DESIGN REVIEW AND PRESERVATION BOARD
SACRAMENTO, CALIFORNIA

ITEM NO. 7
September 16, 1998

PB98-043

Review of a proposed 10 unit single-family detached residential development.

1 ROOF PLAN
 A3 1/8" = 1'-0"

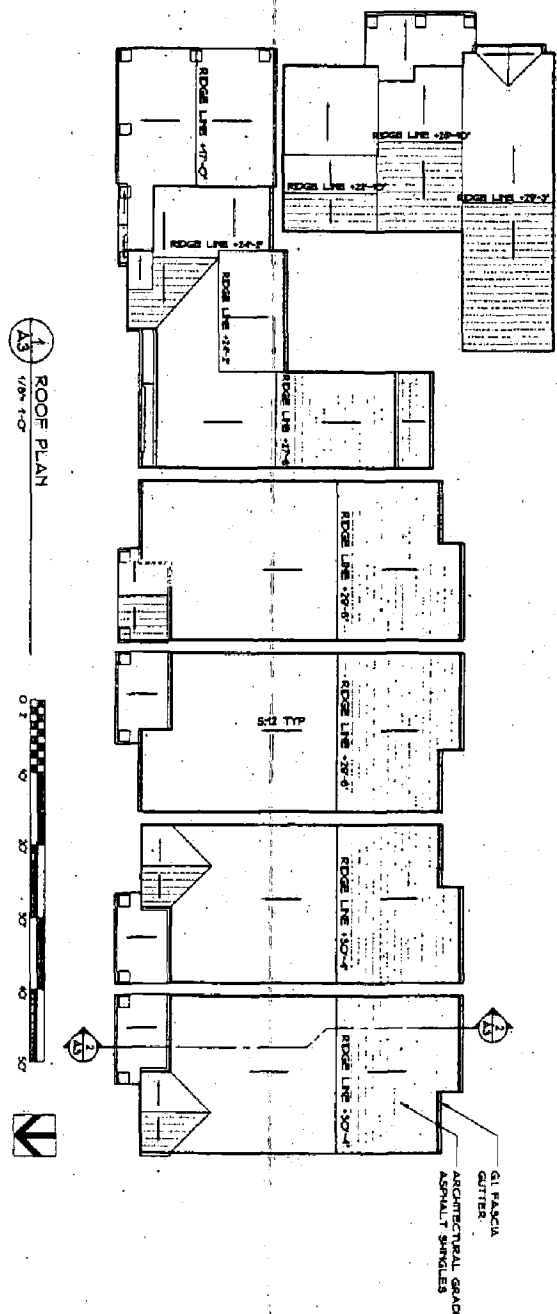
1. The Board may wish to consider commenting on the desirability of varying the treatment of the roofs among the 8 type "A" units. Although variation in the standard plan of unit type "A" is achieved with use of alternative roof treatments over the front porches and over the square window bay of bedroom #2, a greater variety in roof lines and orientation would be more harmonious with the area. The proposed use of only side-facing gables for the main roof is contrary to the random pattern that is typical of most block faces in the immediate area. A front facing main gable on only one unit on each street frontage would provide a much greater visual variation than is provided by the small gables over the bedroom bays. Although the applicant provides a variation of 10" in ridge height between each pair of "A" units on each street frontage, a front facing gable on an "A" unit would have a ridge height about 3 feet lower than an adjacent "A" unit with its side-facing gable roof.

4. SOUTH ELEVATION (F STREET)
A5 1/8" = 1'-0"

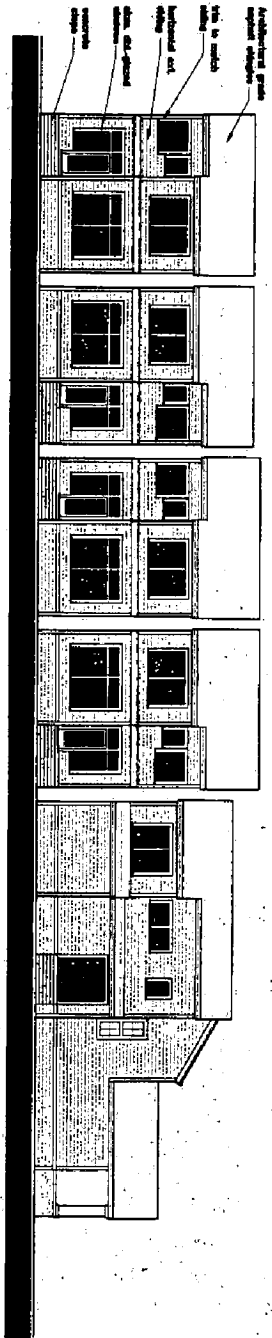
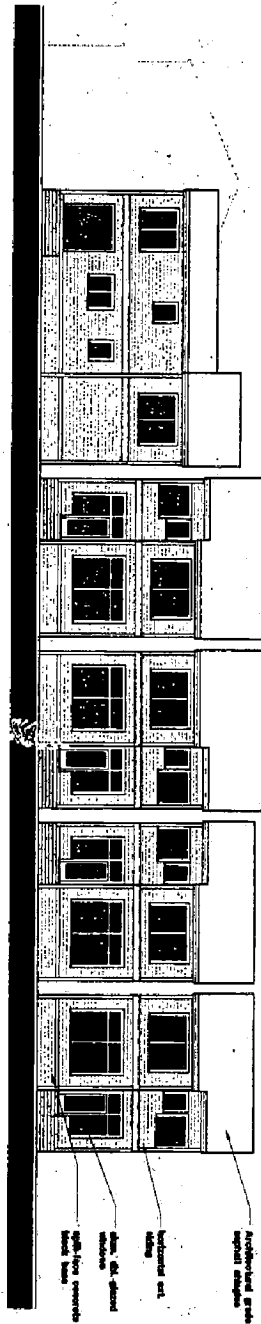
- b. It would be beneficial to add windows to the south side of unit 10A to avoid a blank wall effect at the alley. The added mass of the large gable end above this wall would add further to the negative visual impact of a windowless facade visible to 13th Street.

1 DETAILED PORCH ELEVATION
 1/8" = 1'-0"
 ALL WINDOWS TO BE SPACED EQUAL

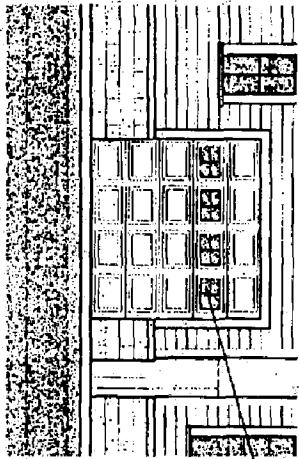
- a. Per the staff request, the applicant has supplemented the plans with additional porch details and information about the concrete block sizing and pattern (A6.1). The split face block is a standard 8" x 8" x 16". A staff suggestion to the applicant was to provide a longer than standard block size.

porch/stair details of the typical unit, including balustrade, columns, steps/treads

2 DETAILED GARAGE DOOR ELEVATION
 1/8" = 1'-0"

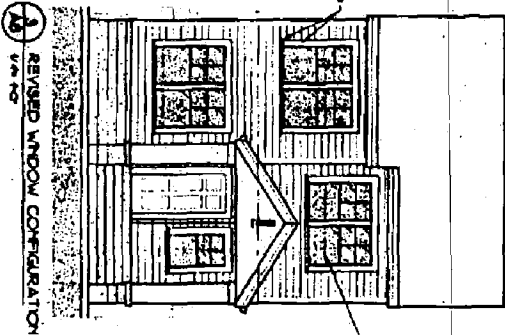
- d. In response to staff comments, the applicant revised the street facing garage doors to include some glazing. However, several neighbors are concerned that this change---prompted by a staff suggestion that the garage doors not present a relatively blank surface---will encourage break-ins. The applicant will look for another means of addressing the staff concern.
- e. Staff would suggest consideration of a warmer color palette for the project, or more accent elements with complementary warm colors.

use raised panel metal doors; aesthetics of street-facing garages of particular concern, so also provide windows.

SHRUB LIST & LEGEND

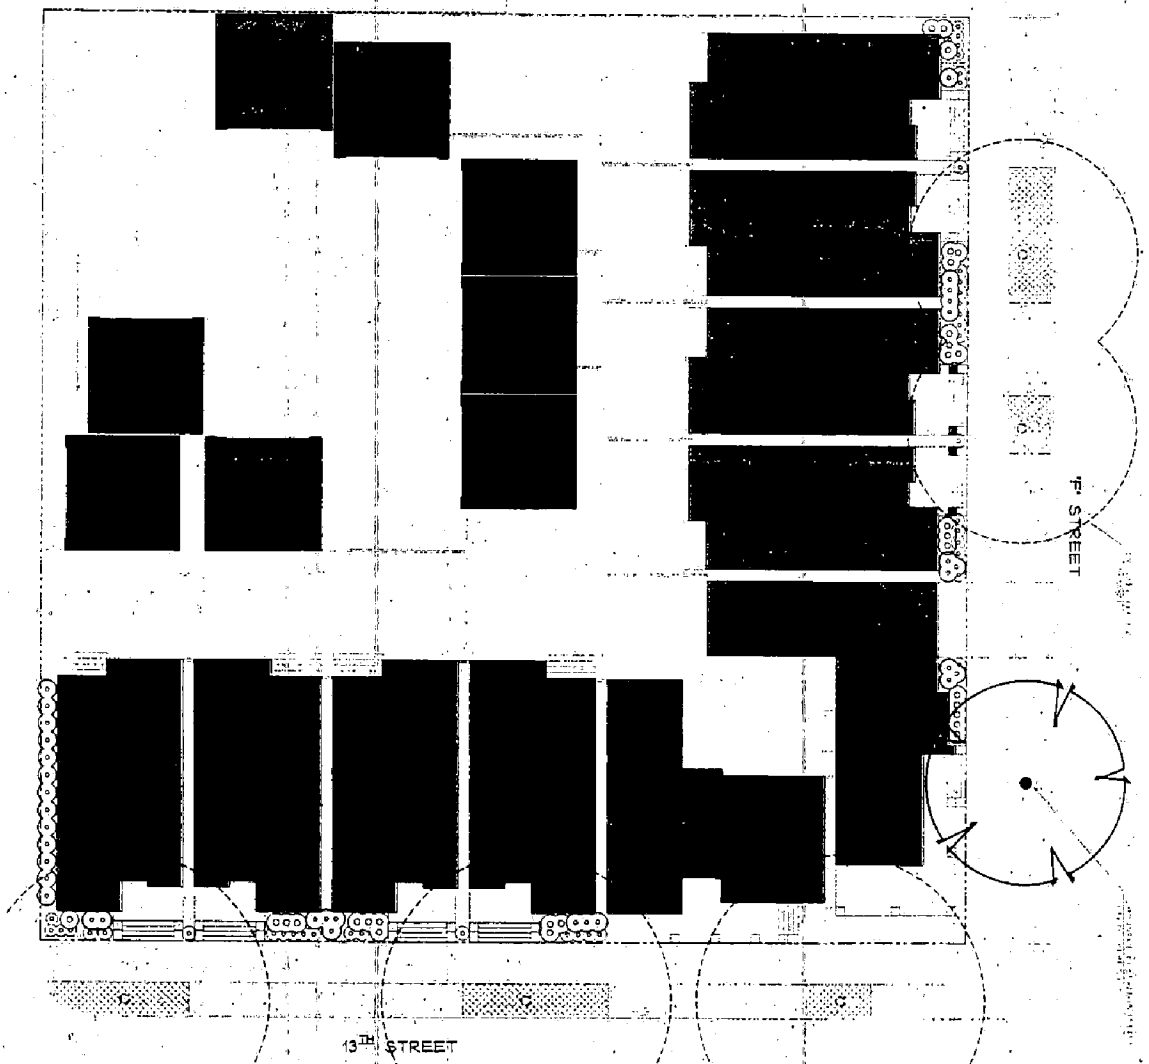
The Board may wish to consider commenting on treatments to enhance the alley/drive/garage area. In the initial staff comments faxed to the applicant a suggestion was made to provide landscaping to enhance alley/garage areas, using available locations and short sections along walls for shrubs/vines. In response, the applicant indicates a willingness to provide enhanced hardscape to these areas; but not landscaping. The fact that there is no common area involved in the proposed project was indicated as a factor that precludes the provision of landscape enhancements. Staff, however, would suggest that the guideline specifically referring to the design of parking areas, and the overall desirability of landscaping in the urban environment and the significance of alleyways as part of that urban environment identified in various adopted City plans, justify landscape consideration beyond what is proposed along the street frontages and within the private spaces of the individual units. Recognizing that a cold water supply is likely to be provided to the rear yard of each property, the further extension of these lines would be appropriate not only for the irrigation of the suggested landscape areas but also for other uses in and around the garages such as an occasional carwash, etc.

provide landscaping to enhance alley/garage area, using available locations and short sections along walls for shrubs/vines.
